Product Change Notice

Part Numbers affected: CL2-2.5-xxxxx, CL2-5.0-xxxxx, and CL2-10-xxxxx (where xxxxx represents any P/N in the series)

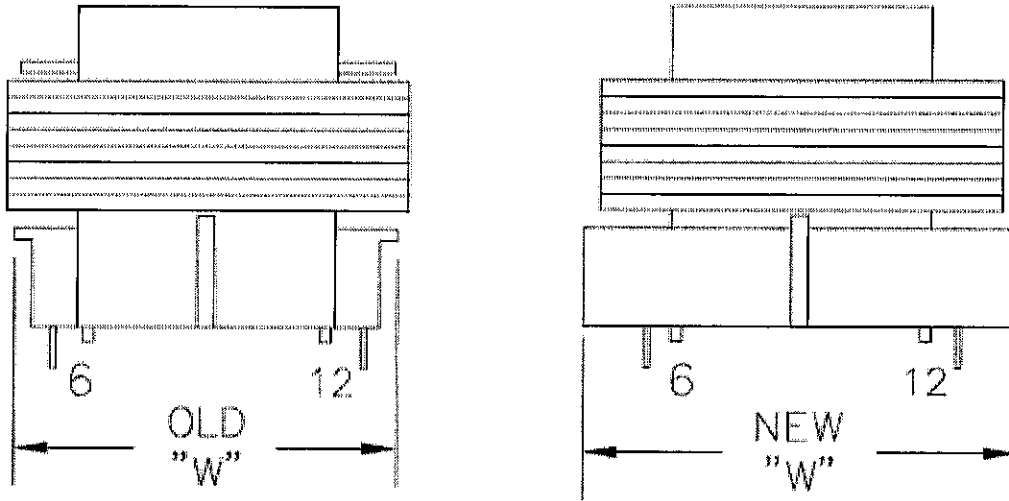
In our continuous efforts to provide product enhancement and ensure unparalleled component reliability, we have upgraded the design of our Class 2, (CL2 - printed circuit board type transformers).

The modified design provides superior resistance to shock and vibration while maintaining consistent connectivity.

The design modification has no impact on the mounting scheme and existing terminal spacing. Therefore, your existing P.C. boards configured, to the original CL2 transformers, will readily accept the revised CL2 series components.

Easily identifiable, the revised CL2 series part number includes the alpha character "R" in the P/N print (example CL2-2.5R-xxxxx).

Note: To accommodate the enhanced terminal design, the protective shroud on VA sizes 2.5 and 5.0 required a slight modification. The shroud modification resulted in a minor 0.120", (3.2mm) overall increase in the width, (W) dimension, (please see attached drawing).

VA size	Old "W" inches (mm)	New "W" inches (mm)
2.5	1.31 (33.3)	1.43 (36.5)
5.0	1.31 (33.3)	1.43 (36.5)
10.0	1.56 (47.6)	1.56 (47.6)
